NORTHEAST UTILITIES

Millstone Nuclear Power Station, Unit No. 3
Structural and Geotechnical
Engineering Branch
Additional Information in Response
to Confirmatory Items

Attachment I

Revised Responses to Structural Audit Items:

REVISION 0

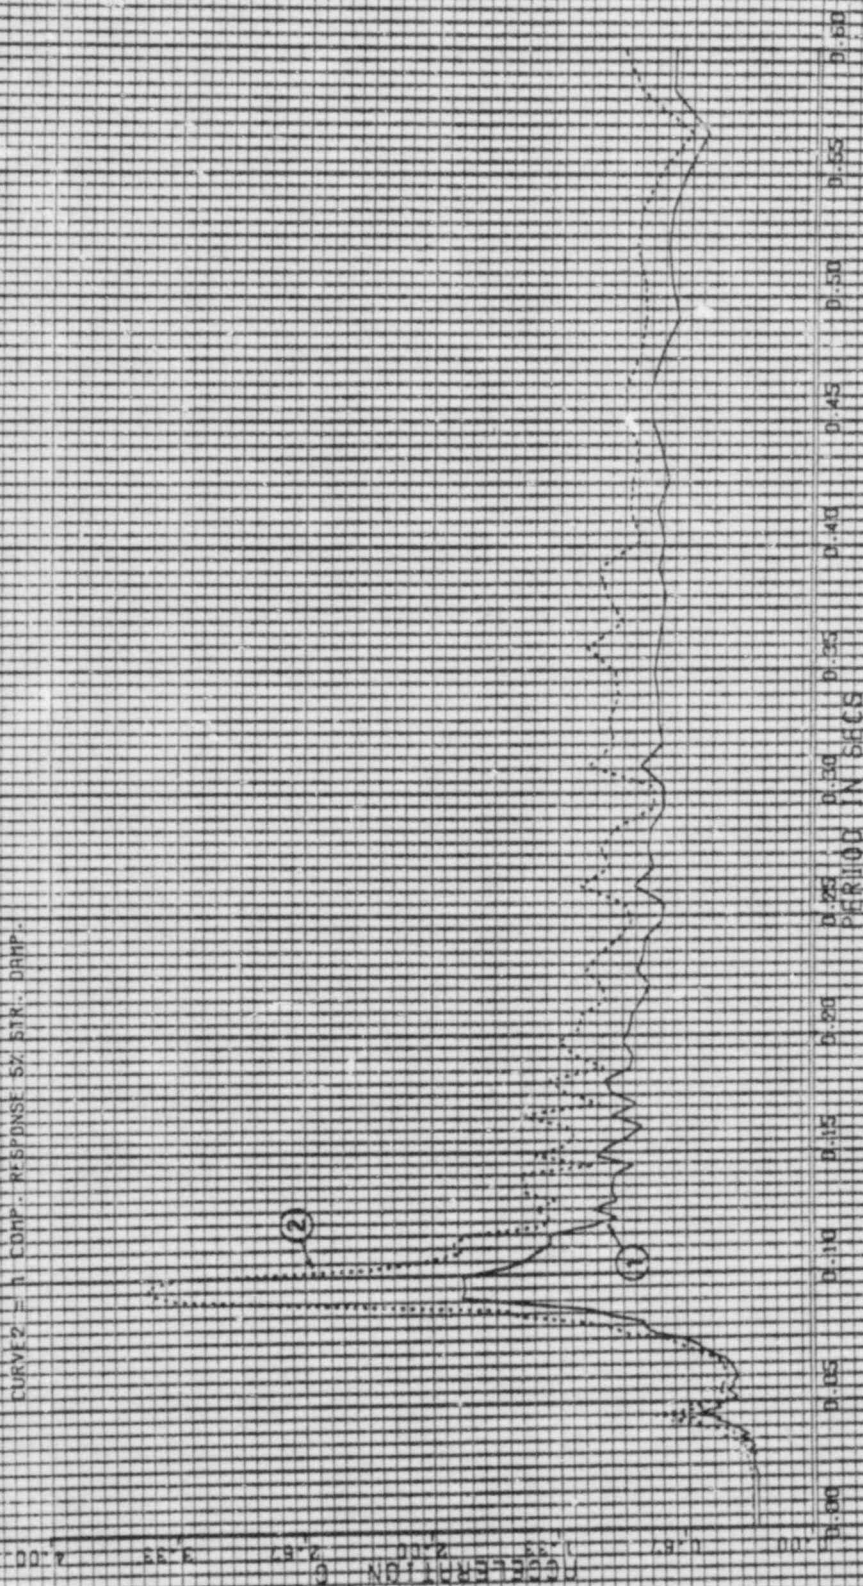
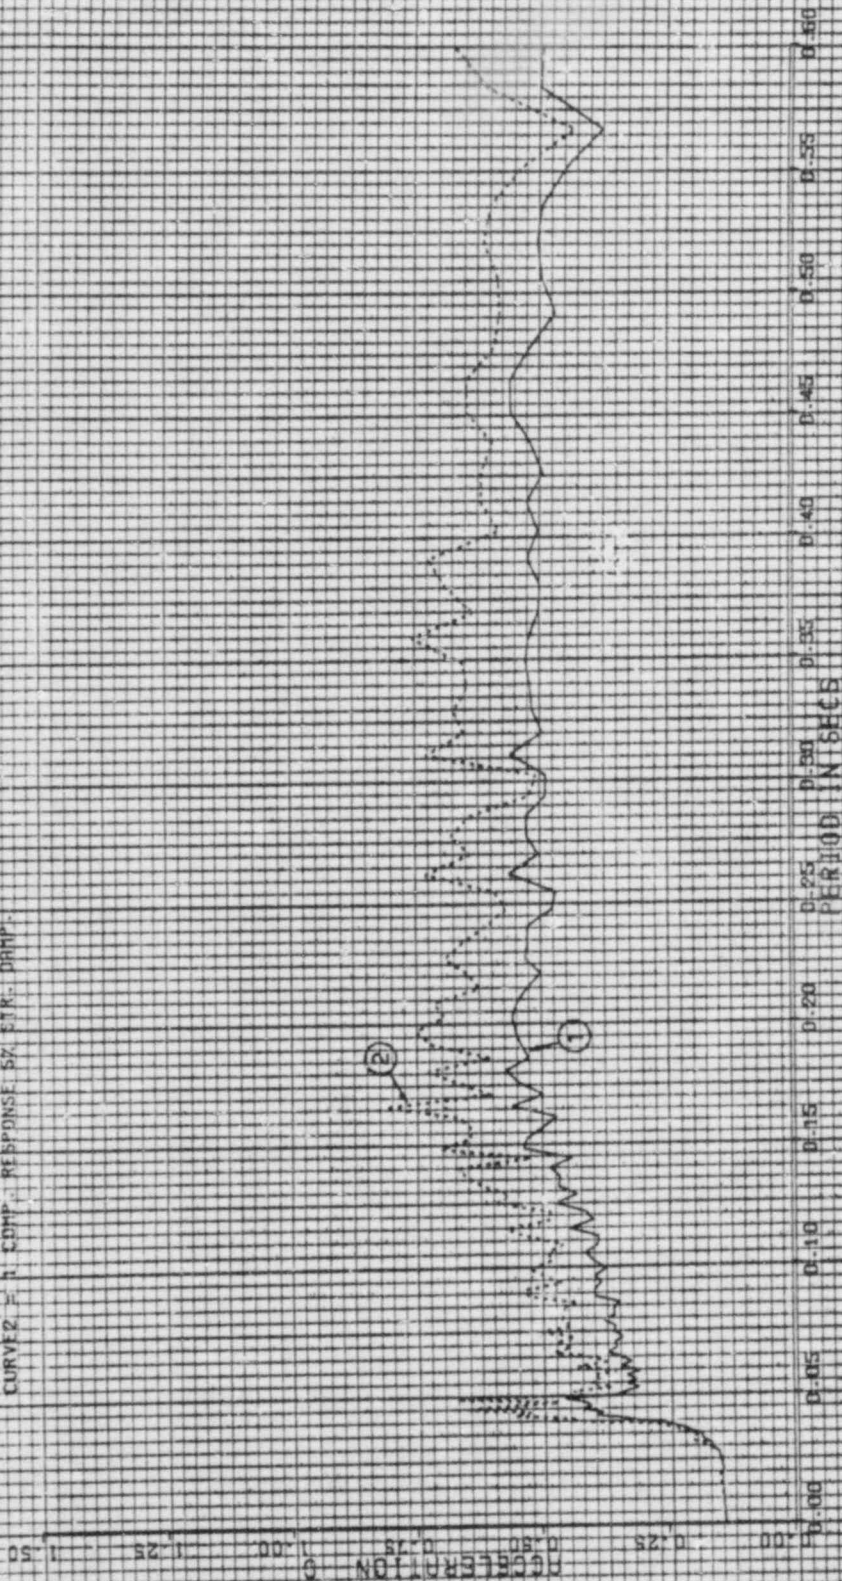
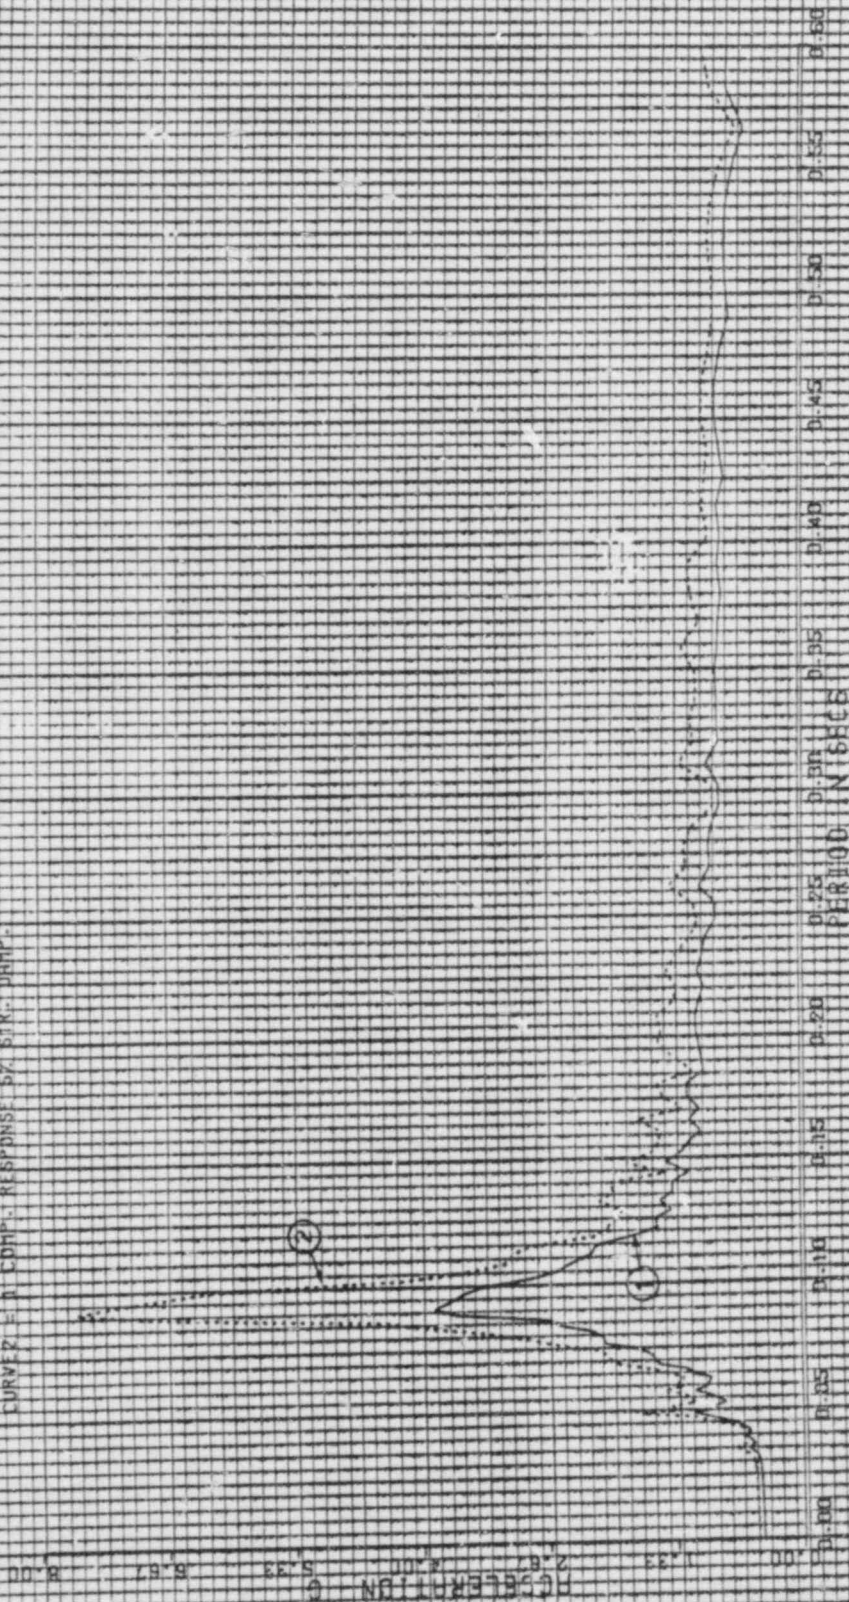
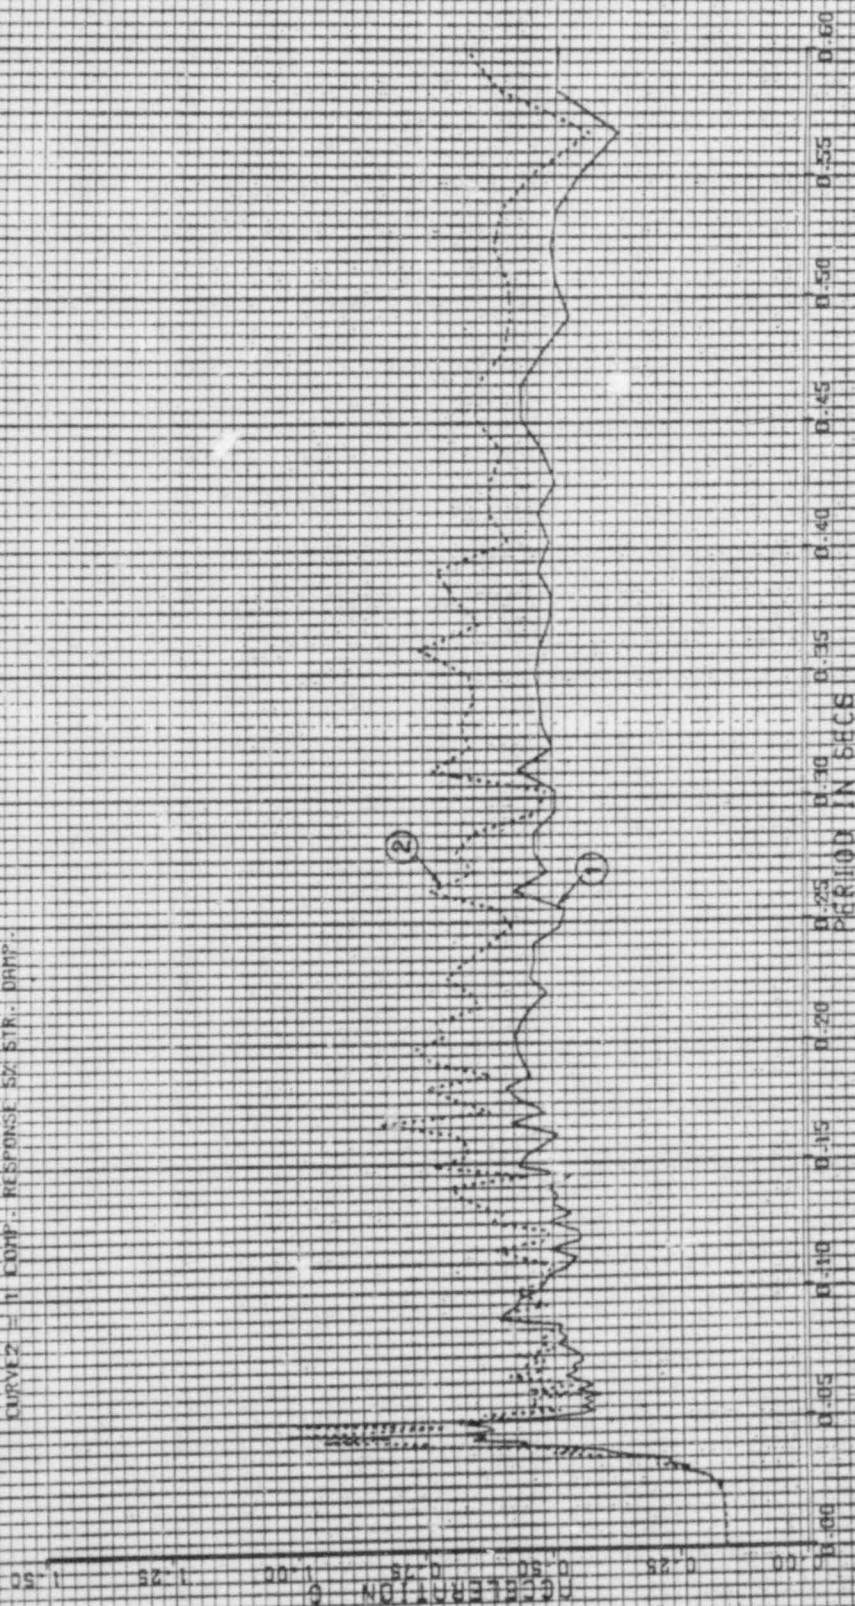
ITEM 27: Provide Justification for Generation of ARS Based Upon One
- Component of Input Motion

The method and criteria used in the generation of ARS for Millstone Unit 3 are inherently conservative. Conservative damping values are used both for structures and equipment. The conservatism in those damping values can be seen when they are compared with the recognized conservative values in Regulatory Guide 1.61. In addition, the input time history used to generate the ARS envelopes the design response spectrum as shown on Figures 3.7B-3 through 3.7B-8 of the FSAR.

To evaluate the conservatism of the one-component ARS curves, a study was conducted to provide a comparison between ARS developed for the SSE condition using:

1. One-component response with 5 percent structural damping and 1 percent oscillator damping.
2. Three-component response (SRSS of the three ARS components) with 7 percent structural damping and 2 percent oscillator damping.

To assure a study representative of all Category I buildings, the Containment Structure, Auxiliary Building, and Fuel Building were evaluated. The Auxiliary Building is representative of all Category I buildings with little coupling, and the Fuel Building is representative of buildings with a large degree of coupling. In every case, the ARS were generated for SSE condition using the three-component response and are enveloped by the response spectra that have been used in piping and equipment qualification.

The attached amplified response spectra curves used in the study are provided for the above buildings in the direction of E-W, N-S and vertical excitation are as follows:

Therefore, it is concluded that the one-component ARS curves developed for all Millstone Unit 3 Category I buildings are conservative with respect to the three-component ARS curves.

Fig 2.3.1

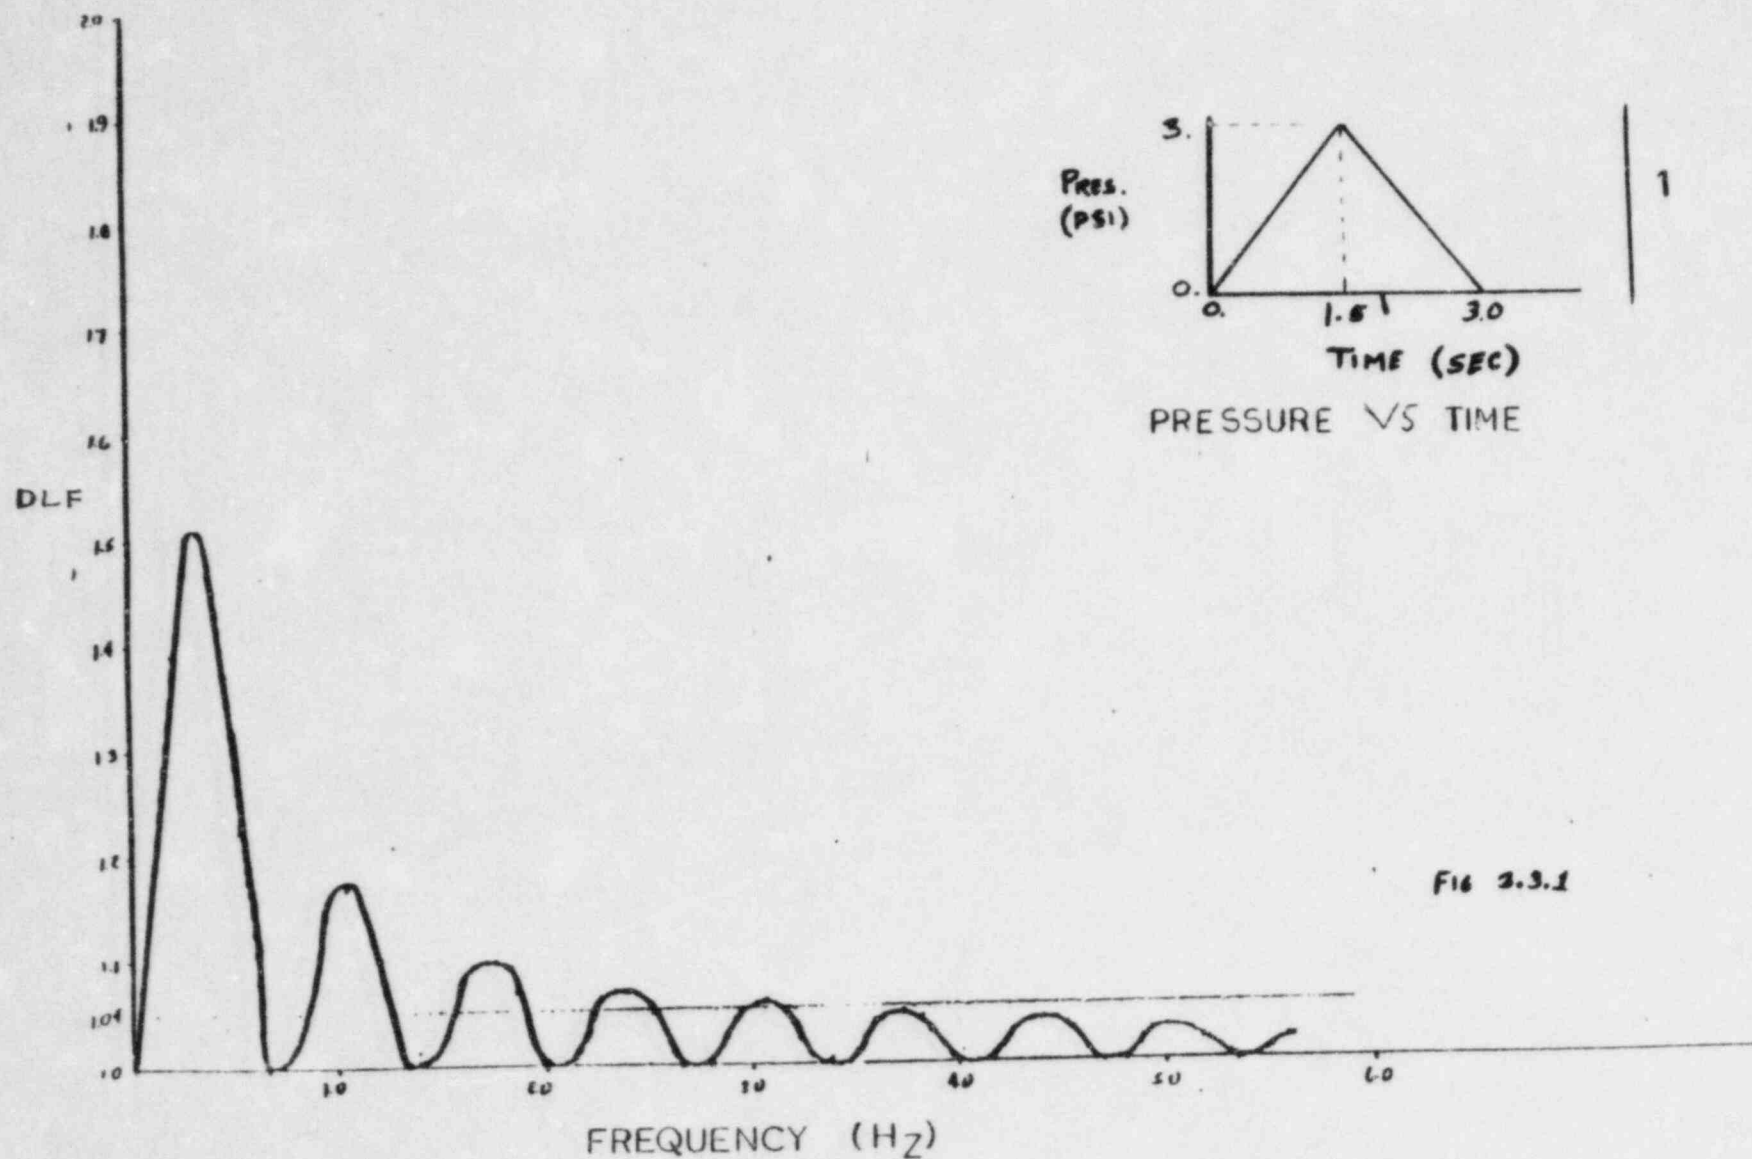
ITEM 33 Justification of unity DLF of pressure drop provided description and results as presented. Resolved. The Applicant will provide the response.

A dynamic load factor of 1.0 is applied to the pressure drop since all wall and floor panels subject to pressure drop have frequencies greater than 4 Hz as shown in Table 3.3.1. Figure 3.3.1 presents the pressure drop time history and the calculated dynamic load factor curve for the pressure drop. Comparing the two it is evident that the Millstone III structural elements experience no dynamic amplification during the pressure drop condition. | 1
